## Product Change Notification

1. ECN #: 261058

- BNC7T - TRUE 75 OHM, BNC STR JACK SHELL

Existing & New Design (Rear View)

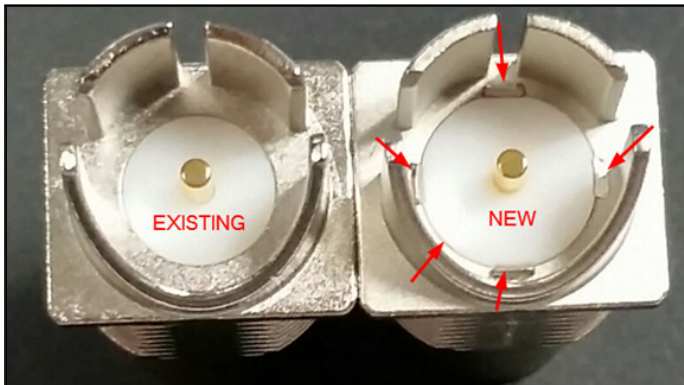
Four tabs were added to the PCB termination area of the connector to increase retention on the white insulator during reflow heat. The diameter of the insulator increases from 7.32mm to 7.48mm.

The new revision of material will have 4 bent tabs equally spaced on the rear of the connector. The diameter of the insulator material from the rear of the connector will measure an estimated 7.48mm.

The four tabs were added to increase the retention of the insulator during lead free reflow processing.

- Form - 4 bent tabs are added to the rear termination area of the connector.
